Model: NAD 30S/30/40 (3000-sheet Finisher)		Date: 30-Jun-98	No: 7
Subject: Paper rolled-up on the shift tray		Prepared by: M.Mimura	
From: QAC Field Information Dept.			
Classification:	☒ Troubleshooting	☐ Part information	☐ Action required
	☐ Mechanical	☐ Electrical	☐ Service manual revision
	☐ Paper path	☐ Transmit/receive	☐ Retrofit information
	☐ Other ()

Model: NAD 30S/30/40 3000 Finisher		Date: 15-Apr-99	No.: RA230031
Subject: SR730 Stapler Motor Harness Route Change		Prepared by: S. Hizen	
From: Technical Service Dept., GTS Division			
Classification:	☐ Troubleshooting ☐ Mechanical ☐ Paper path ☒ Other ()	☐ Part information ☐ Electrical ☐ Transmit/receive	☐ Action required ☐ Service manual revision ☐ Retrofit information

Model: 3000 Finisher for SP5/SP5L		Date: 15-Oct-99	No.: RA229017
Subject: SC621		Prepared by: A. Sasaki	
From: Technical Service Dept., GTS Division			
Classification:	☒ Troubleshooting ☐ Part information ☐ Action required ☐ Mechanical ☐ Electrical ☐ Service manual revision ☐ Paper path ☐ Transmit/receive ☐ Retrofit information ☐ Other ()

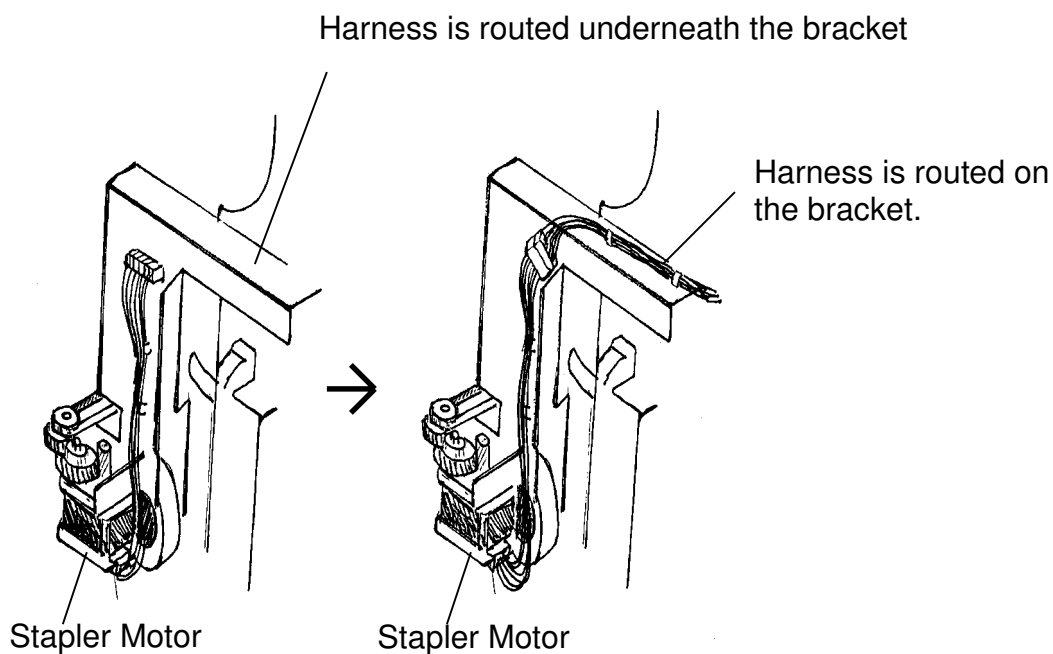
To prevent the stapler motor harness from being damaged, the harness route has been changed as shown in the illustration below:

Cut-in serial number for the harness route change:

- A697 - 15 : 1B59030221~
- 17 : A7779030001~
- 22 : AR39030001~
- 26 : 3R10390001~
- 55 : L0329032032~

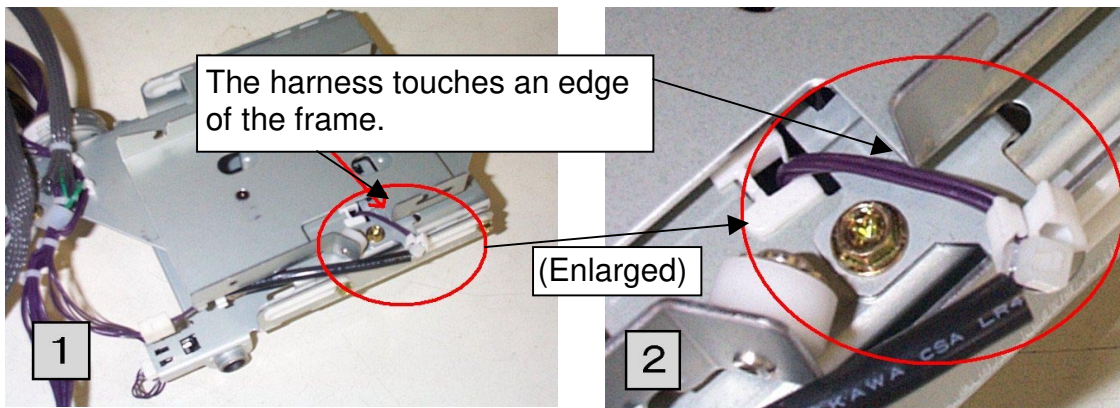
SC621 is generated during copy cycle.

The stapler rotation HP sensor harness shorts to the frame

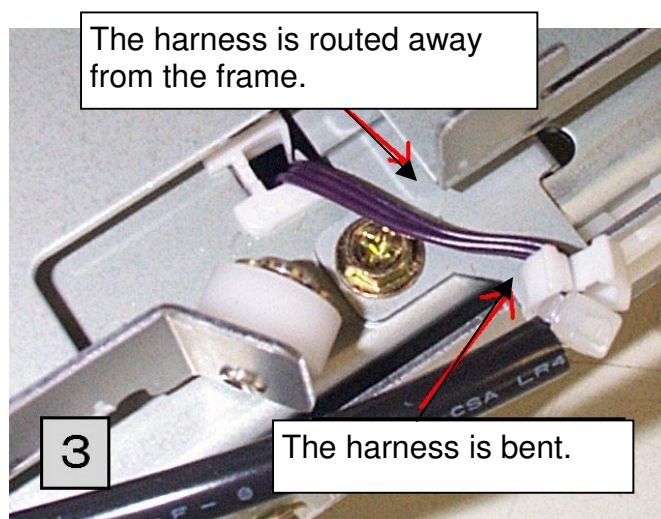
The routing of the harness has been changed as shown in the photo. This can be done in the field.

A tape wrapping the harness has been added to the place where the harness touches the frame and the frame has been changed to make the edge smoother.
